DPD #3024469  
**DESIGN REVIEW RECOMMENDATION PACKET**  
 MARCH 13, 2017

# 4025 STONE WAY N

## 6.0 EARLY DESIGN GUIDANCE BOARD RECOMMENDATIONS & APPLICANT RESPONSES

SETBACK DIAGRAM AT WEST P.L. LOOKING NORTH

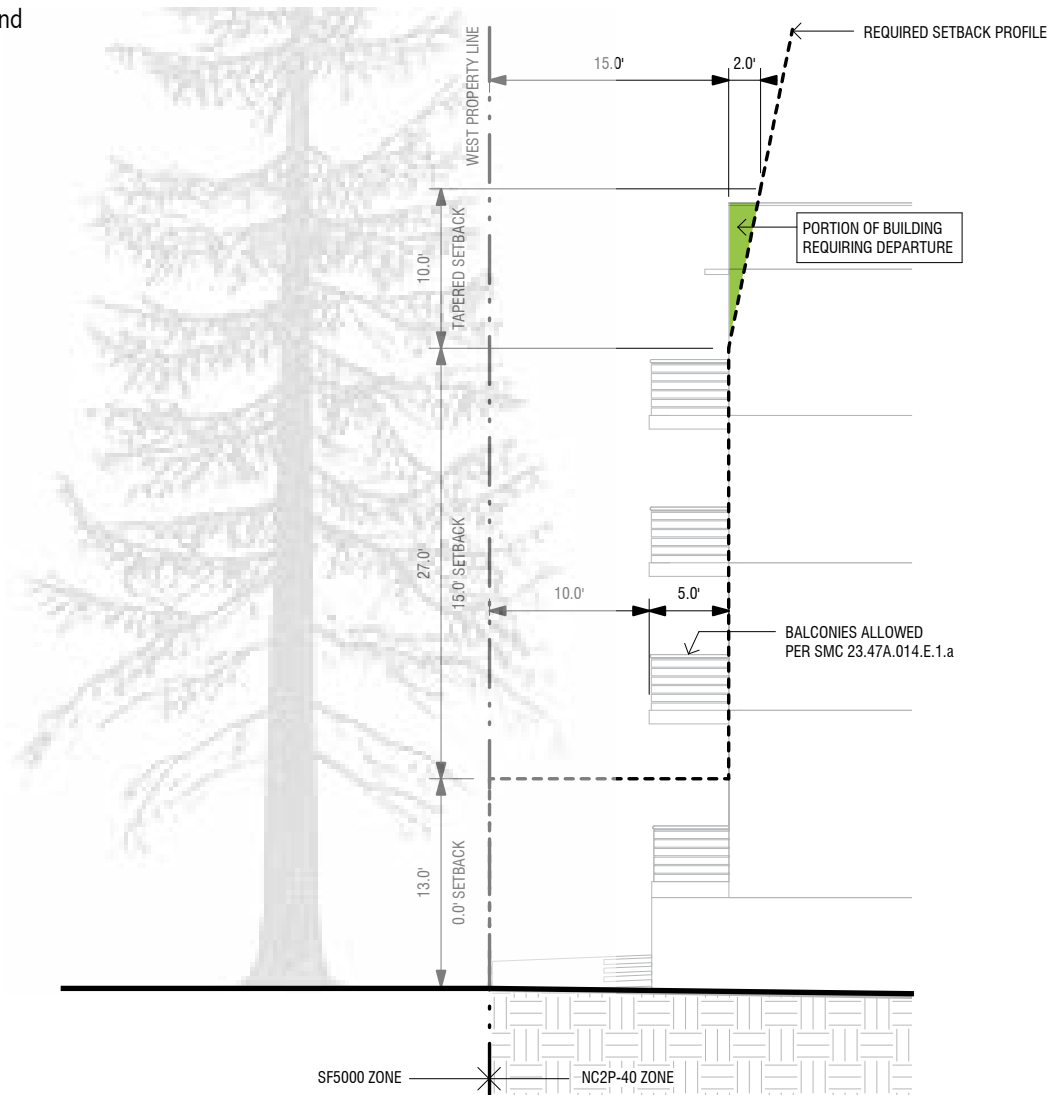
d. The Board discussed the character and long term development of Stone Way N. While some felt upper level setbacks at east property line are valuable, others felt that due to the existing trees, a break in plane would be sufficient. (CS2-C)

Following the setback line per the diagram results in an additional 2' setback at level 4. This additional setback is insignificant in its impact and will complicate construction. Also, large trees already provide screening (CS2.D.2). Instead we propose stepping the building back on the street side, which the board indicated at EDG (comment 3D), would be a reasonable trade-off.

## 11.0 ANALYSIS OF ALTERNATE LOCATION FOR RESIDENTIAL ENTRANCE

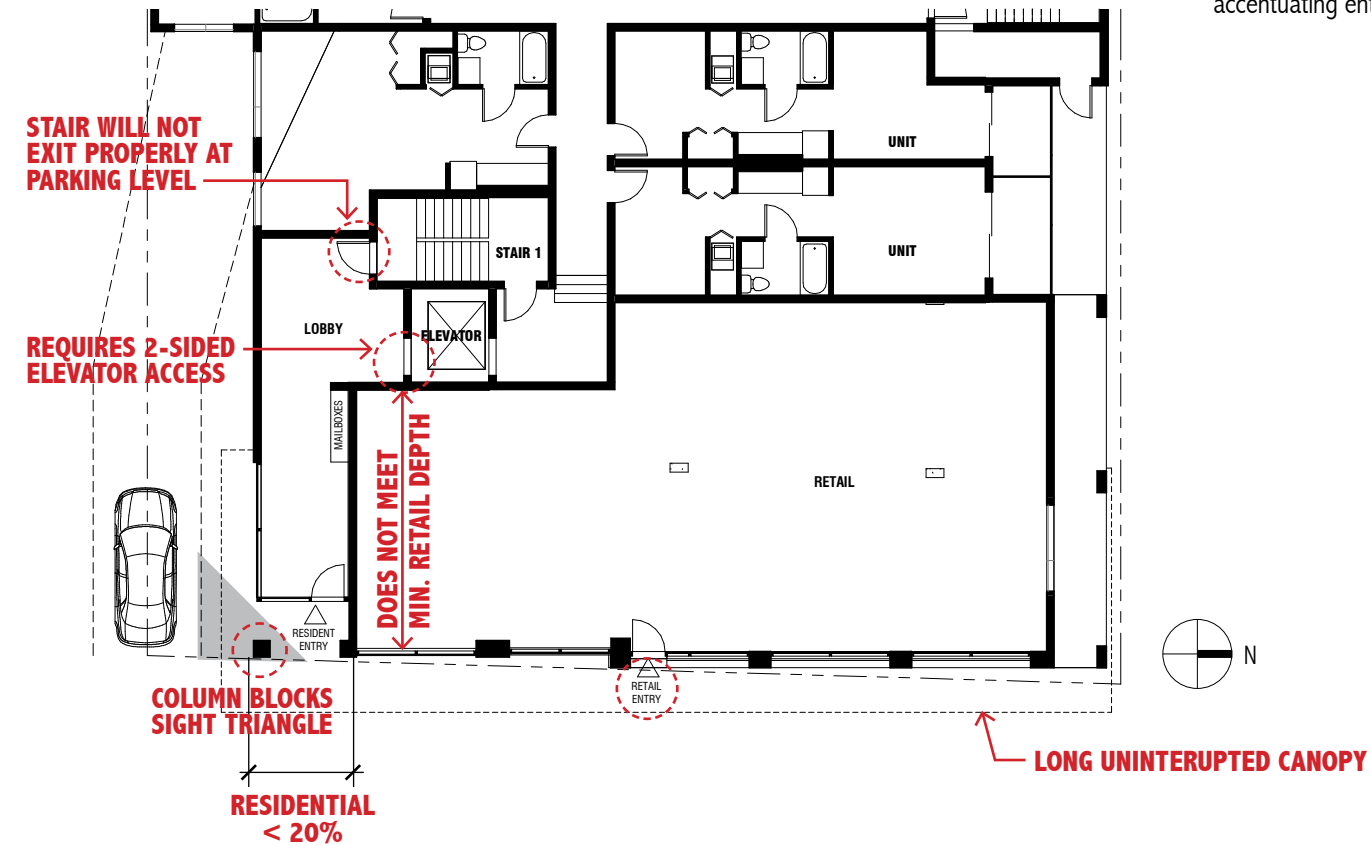
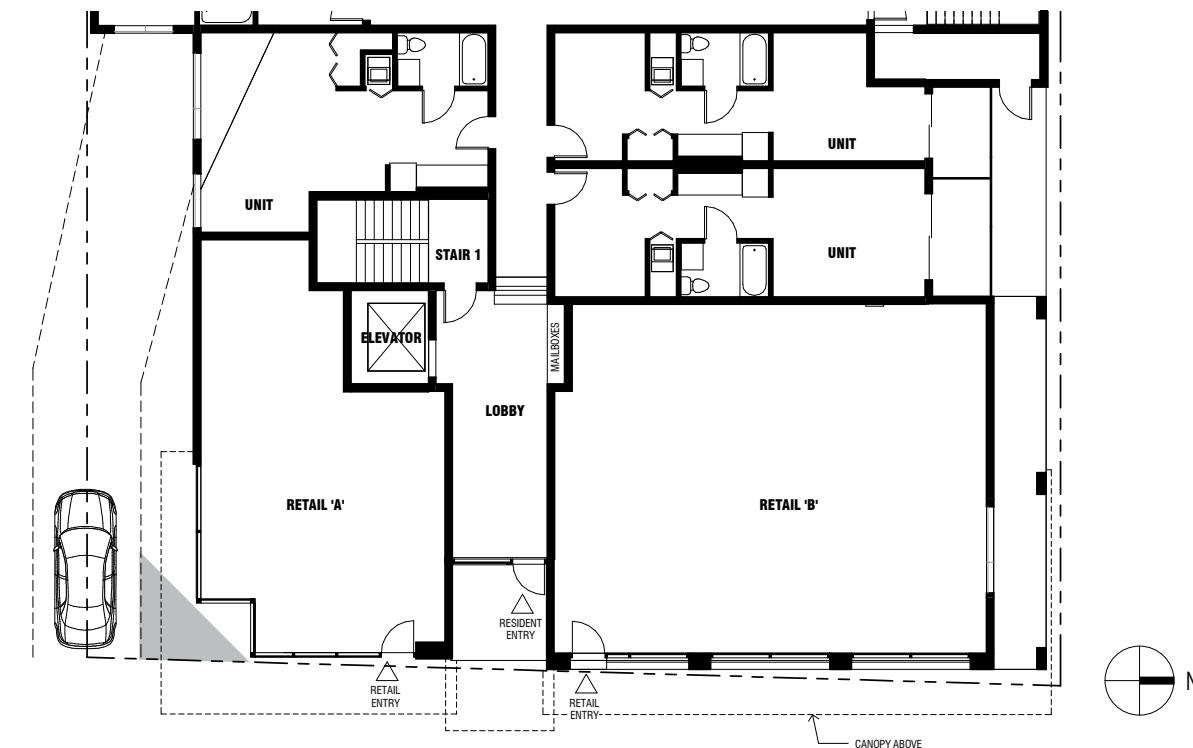
c. The preferred Scheme C proposed four small retail spaces. The Board agreed that one large retail space would be more viable than four smaller spaces. Additionally, moving the residential lobby further south to abut the driveway would support a larger retail space. (PL3-B, PL3-C)

a. The Board supported the primary residential lobby at street level, as shown in Scheme C; however, they recommended moving the lobby adjacent to the driveway at the southeast corner of the site. Explore enhancing the corner treatment to clearly mark the residential entry (PL3-A).

**Response: We have examined the possibility of relocating the residential lobby to the corner. We have determined that it is not a feasible option for the following reasons:**

### PROPOSED SCHEME

- Meets min. retail depth requirement
- Meets owner req'mt for owner-occupied office
- Elevator and stair meet codes efficiently
- Residential entry separated from driveway
- Sight triangle unobstructed
- Facade composition accentuates entry

### ALTERNATE SCHEME

- Pedestrian safety would be compromised if the heavily used public entry is located adjacent to the vehicular driveway
- The retail depth requirement cannot be met with the entry at the corner
- The owner will be occupying the building and the alternate retail space does not meet their specific needs
- We have not been able to find any design precedents for a corner entry. It is very difficult to make it work with code compliant exiting schemes and layouts
- Less retail square footage in this configuration
- Elevator and stair inefficiently laid out
- Facade composition is less clear in accentuating entry
